**Subject: 154 Broad Street  
0 & 172 Greyrock Place - Greyrock Development LLC  
Zoning Application No. 221-14, 221-15, 221-16**

**TO:** Vineeta Mathur, Associate Planner (Via Email)  
**FROM:** Bharat Gami, Chief Building Official  
**DATE:** April 29, 2021  
**RE:** ZB 221-14, 221-15 & 221-16 - 0 Greyrock Place (004-1972), 172 Greyrock Place, and 154 Broad Street. Text Change, Zone Change, Special Permit, and Final Site and Architectural plan and requested uses applications

Subject: **Application 221-14 Text Change; Application 221-15 Rezoning; Application 221-16 Special Permit and Site and Architectural Plans and /or Requested Uses; RMS Companies (Applicant) and Greyrock Development LLC (Owner) - 0 Greyrock Place, 172 Greyrock Place and 154 Broad Street, Stamford, CT**

**TO:** CITY OF STAMFORD ZONING BOARD  
**FROM:** VINEETA MATHUR, ASSOCIATE PLANNER  
**SUBJECT:** ZB #221-14, 15 & 16, Zoning Text Amendment, Zoning Map Amendment, Special Permit and Site and Architectural Plan and Requested Uses  
**DATE:** June 15, 2021

BUILDING ELEVATION 2

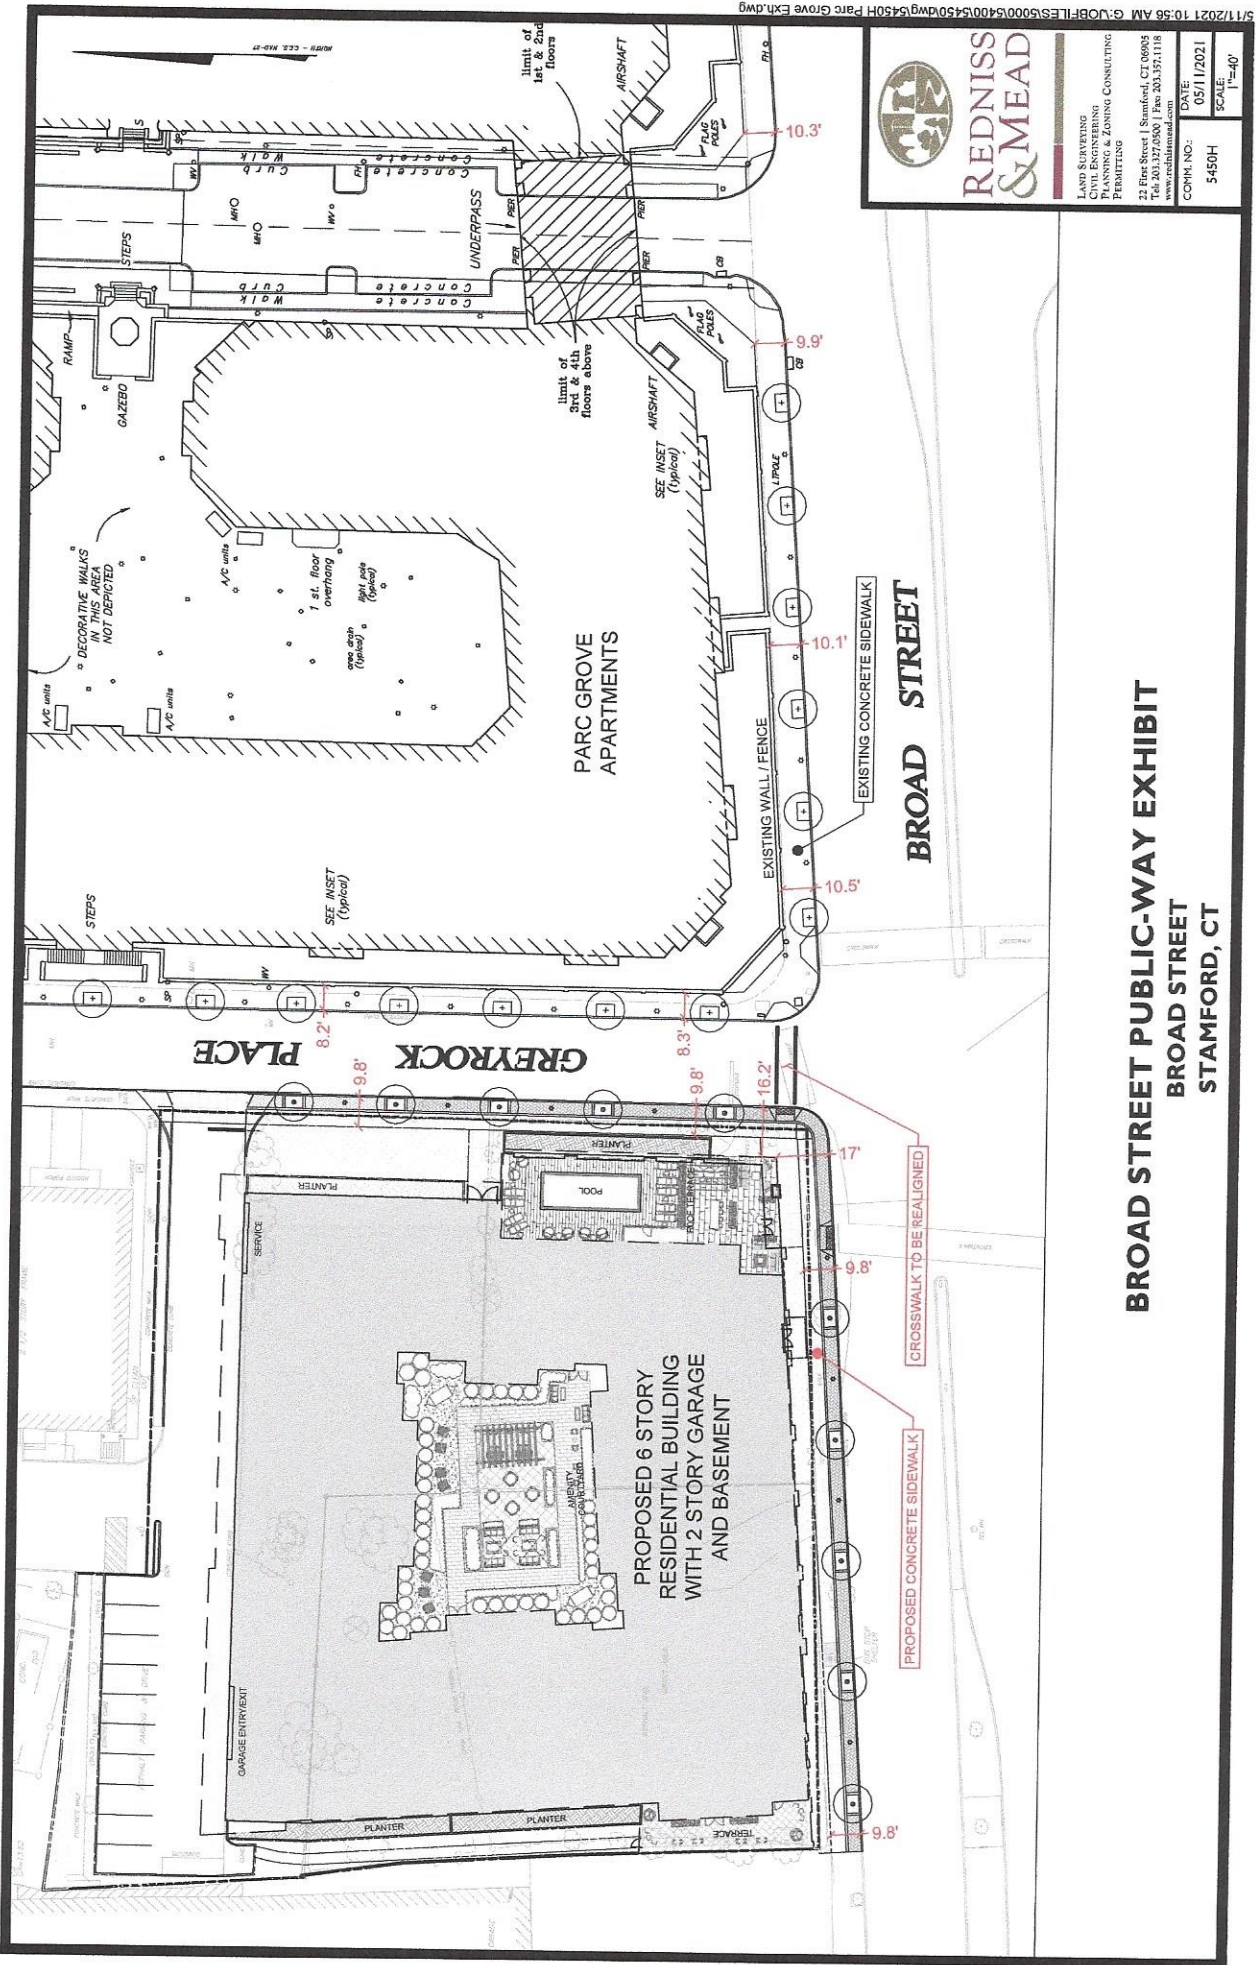
Demonstrate compliance with maximum area of exterior wall openings based on fire separation distance and degree of opening protection, per 2015 IBC Table 705.8 for West wall (Elevation 2).
